Leigh Flood Storage Area Review

Independent audit of operation in the
December 2013 flood

MCR5376-RT001-R04-00

July 2015

Figure 4.4: Water surface area (Hectares) calculated from RBS volumes

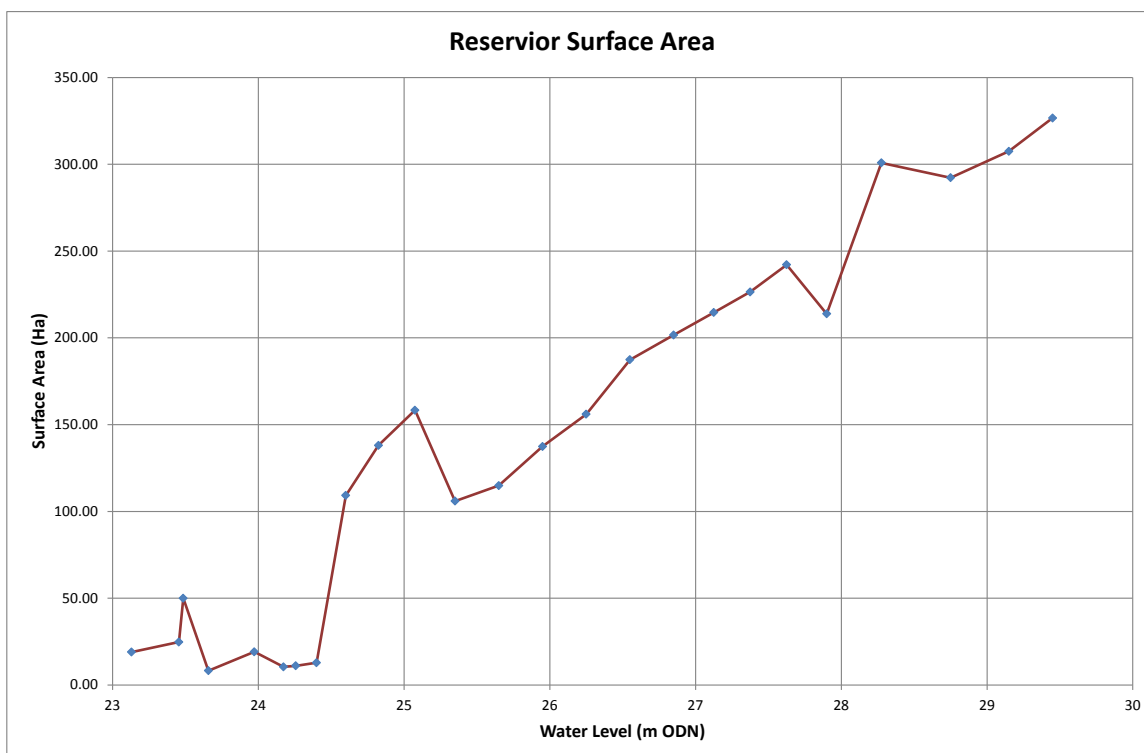
The RBS data, however, shows a degree of scatter around the general trend line and whilst this might appear to be minor when plotted as in Figure 4.2 and Figure 4.3, the variation can have unwanted influence on the calculated inflow rates in the RBS. Figure 4.4 below shows the water surface area implied by the RBS volume data.

The volume data in the RBS increases in all cases as water level increases as is required. However, the water surface area is seen to decrease as water level rises at several places including about 0.5 m above the point of impoundment (water level 24.70 m) and just below the maximum operating level (28.05 m). Such a decrease in area as level rises is not realistic for an open watercourse and flood plain.

The basis of the stored volumes in the RBS must be reviewed to ensure that surface area of the storage reservoir is represented as increasing with water level. The basis of the revision could be the recent (2014) survey, coupled with appropriate assumptions on water surface gradient as the water level in the FSA rises. Alternatively, a more comprehensive investigation of the hydrodynamics of the filling of the reservoir could be undertaken before a revised operational model is derived for the RBS calculations.
